**ADDENDUM NUMBER ONE TO PLANS AND SPECIFICATIONS FOR  
2022 HVAC RENOVATION FOR  
RAINS JUNIOR HIGH SCHOOL  
RAINS INDEPENDENT SCHOOL DISTRICT**

**ENGINEER: EMA ENGINEERING & CONSULTING  
328 South Broadway  
Tyler, Texas 75702**

02/08/2022

SHEET NUMBER  
**MEP1.2**

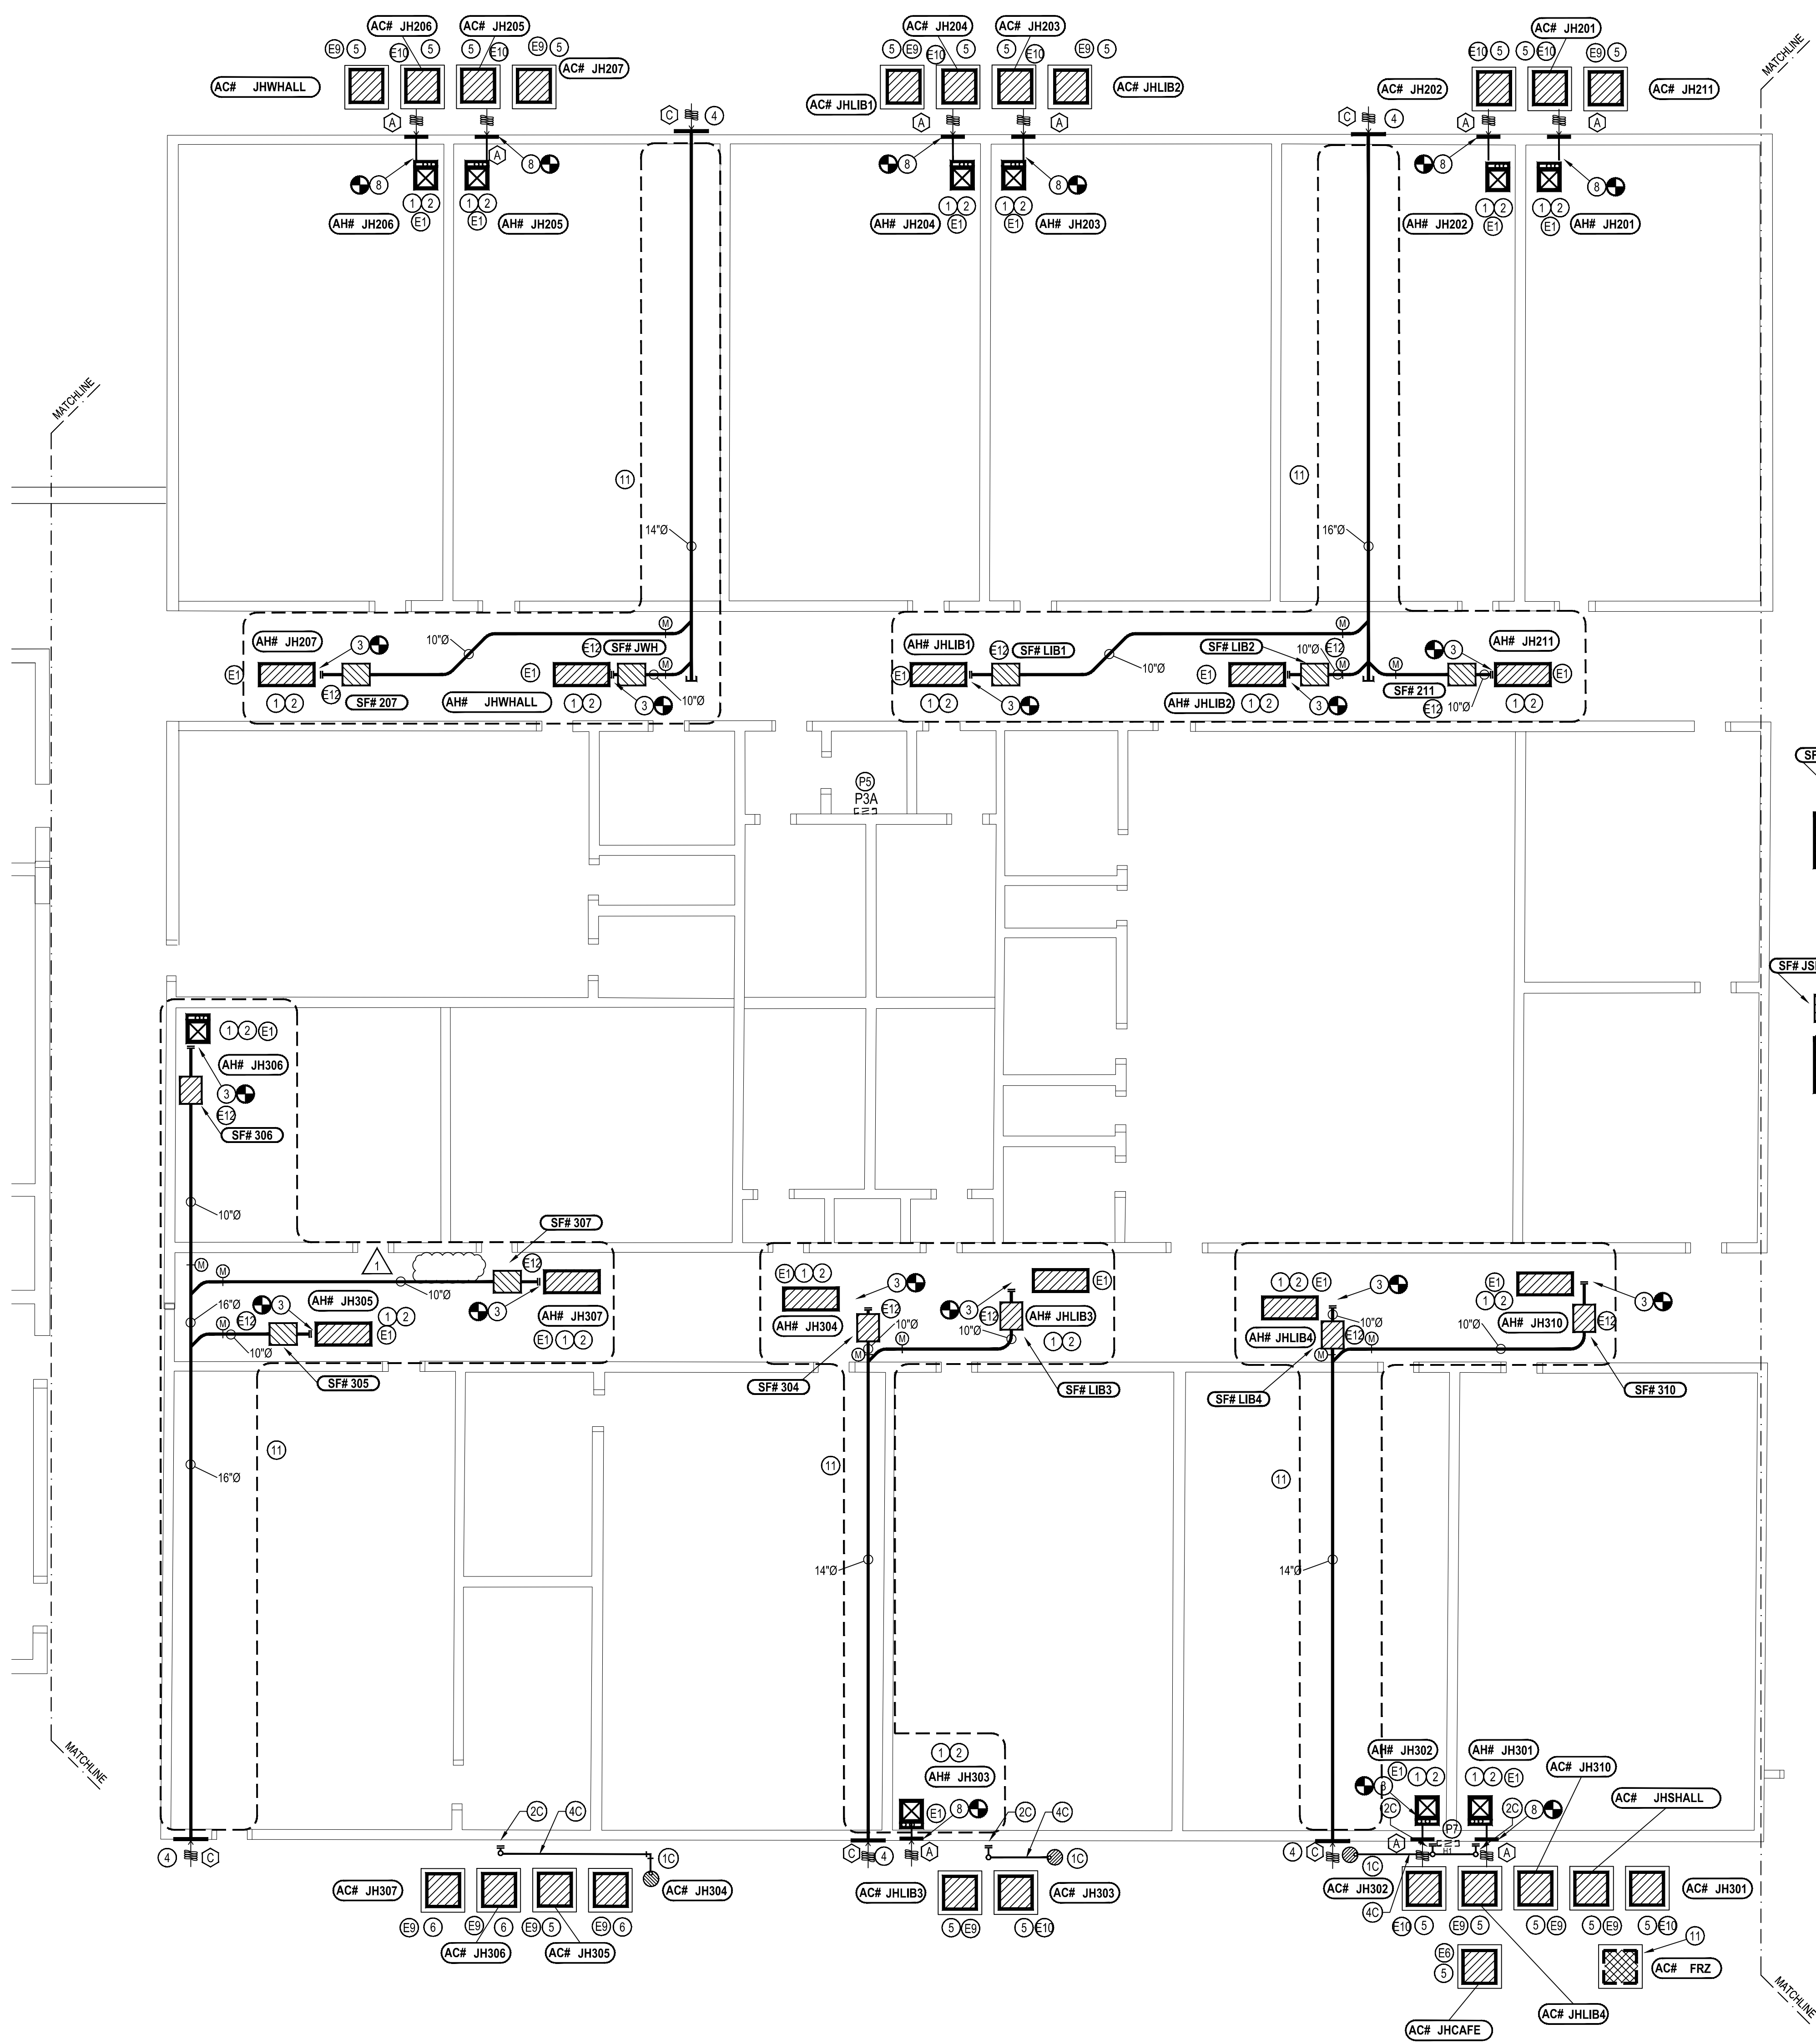
**SHEET MEP1.2**

A. Refer to the attached sheet for added duct detector notation.

SHEET NUMBER  
**MEP1.3**

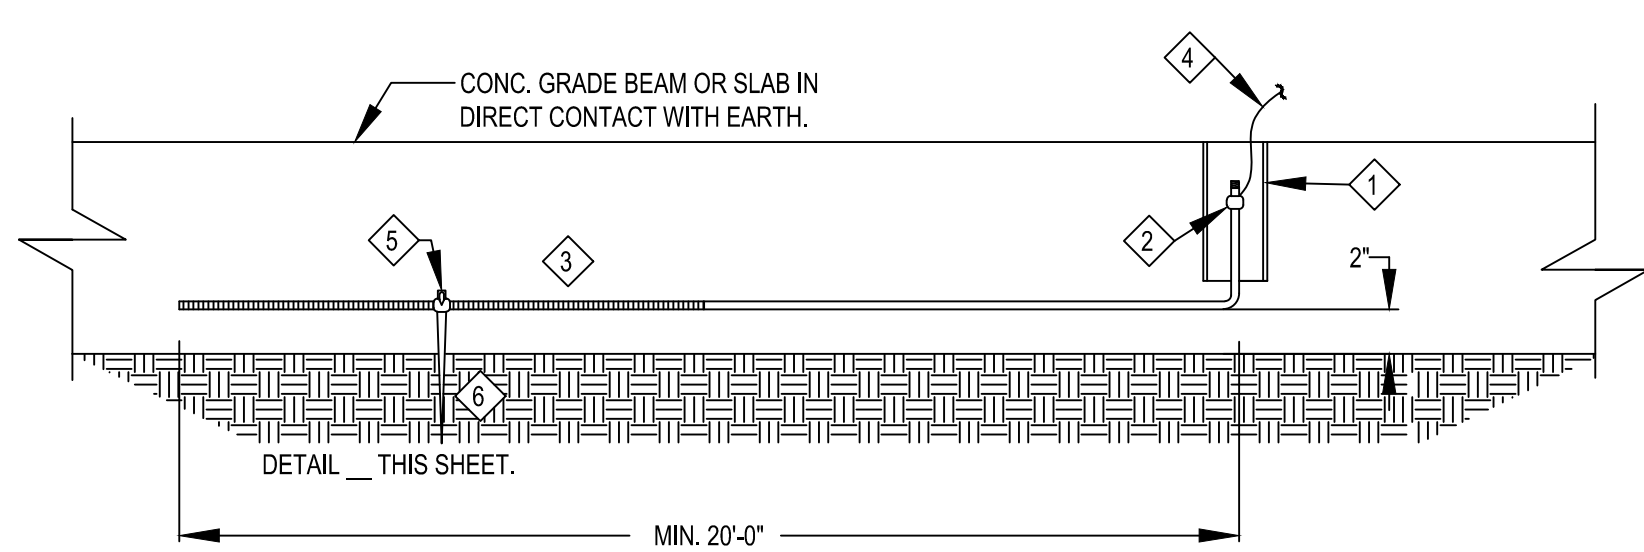
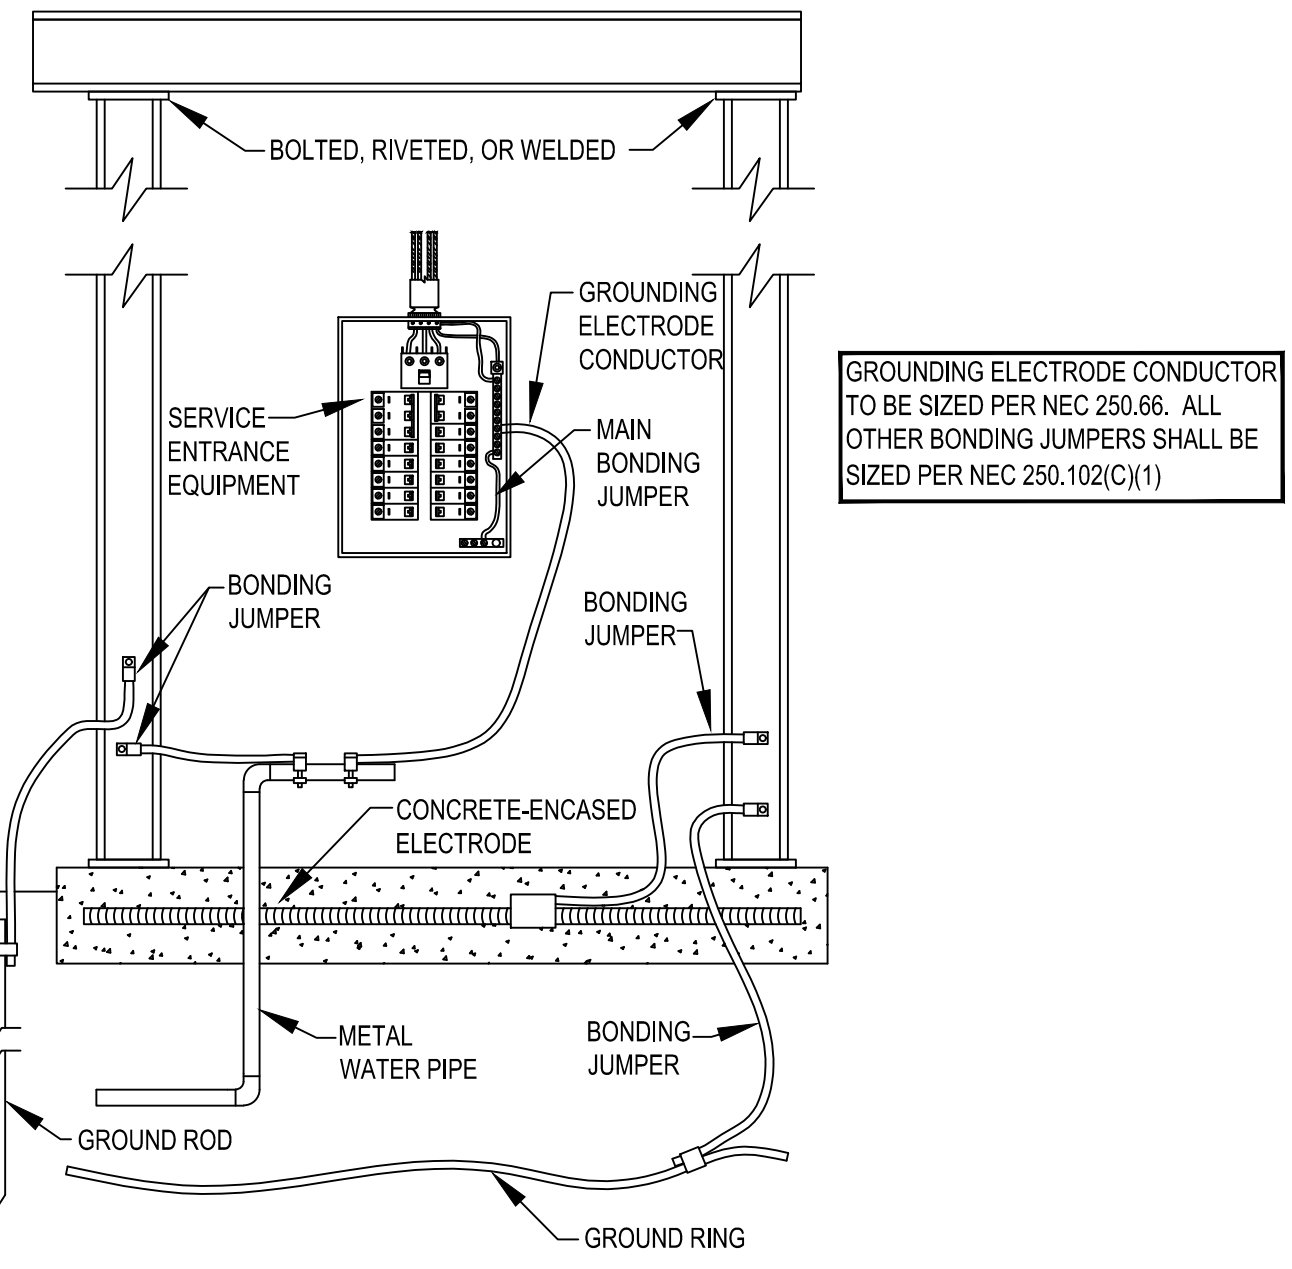
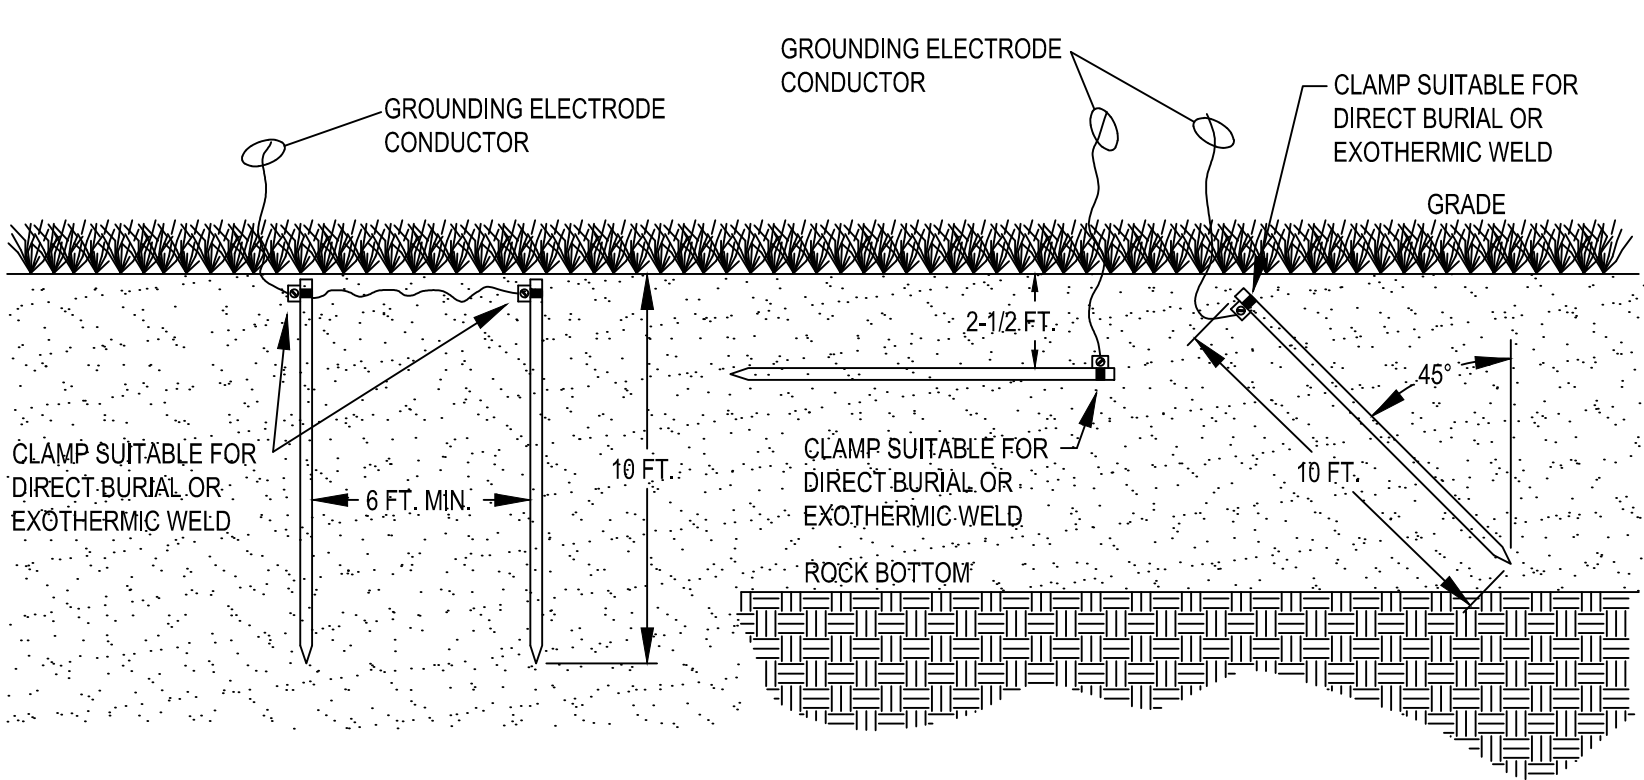
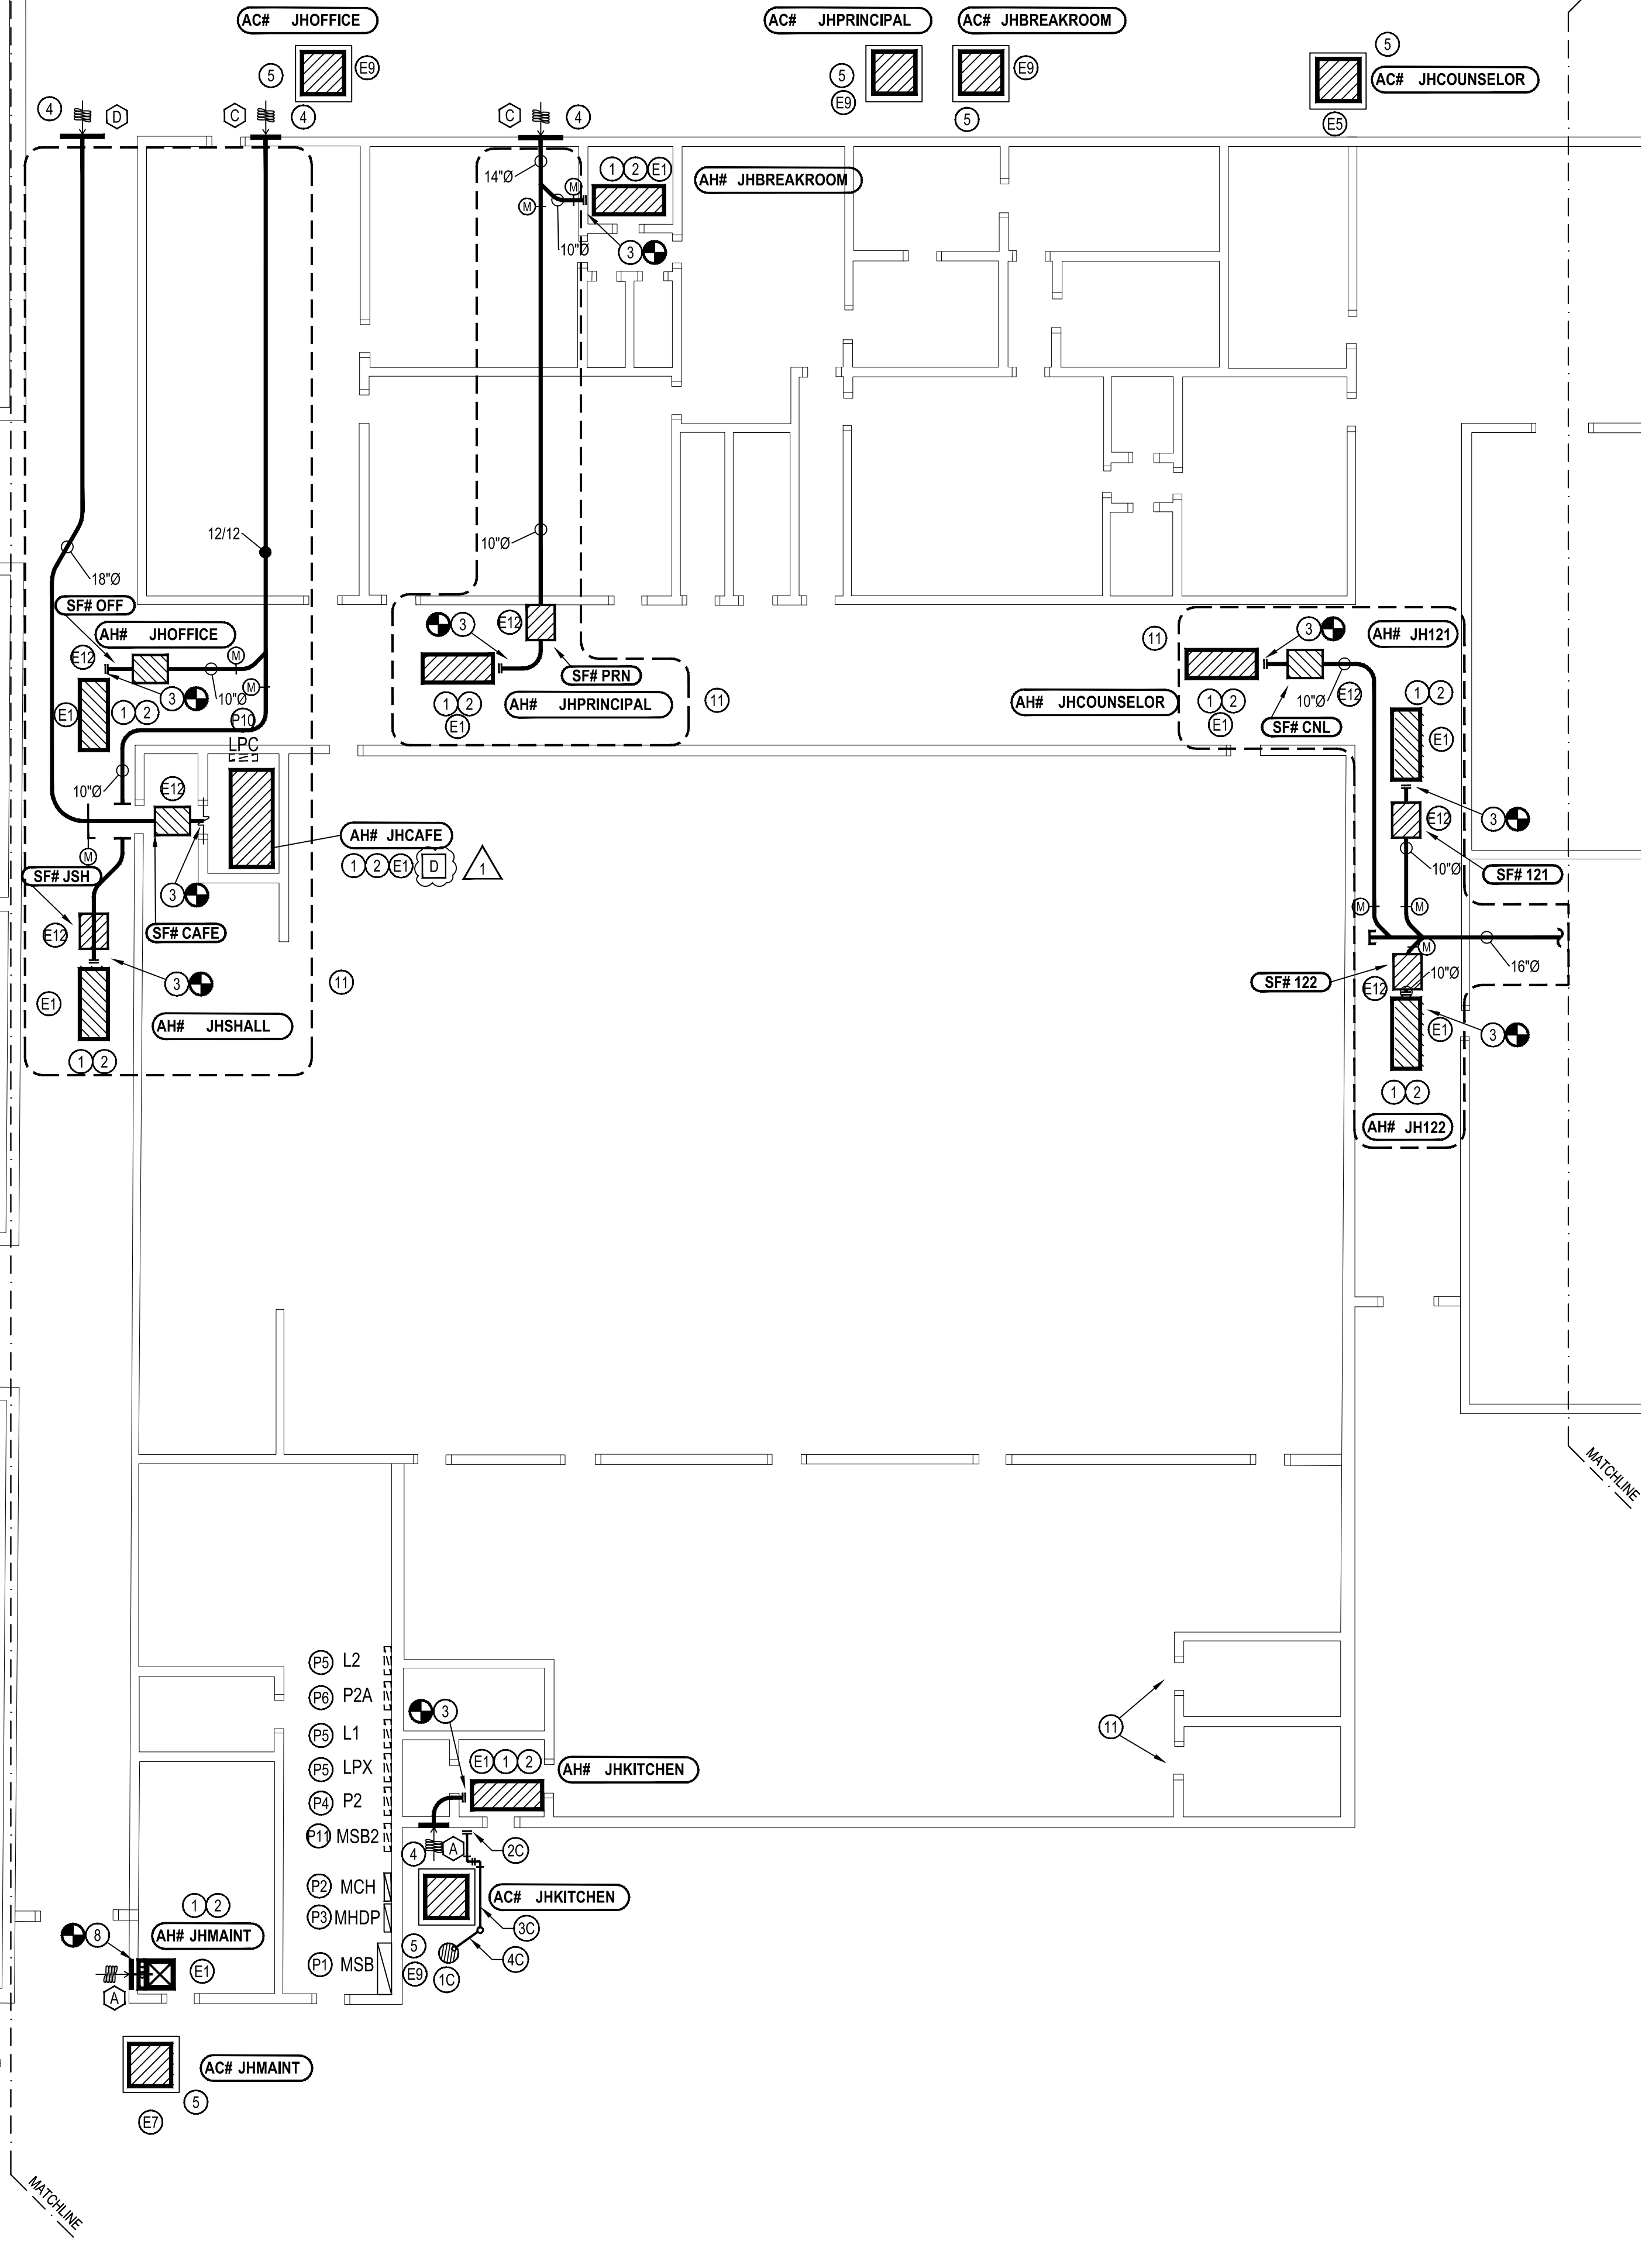
**SHEET MEP1.3**

A. Refer to the attached sheet for plan note and unit tag clarifications.
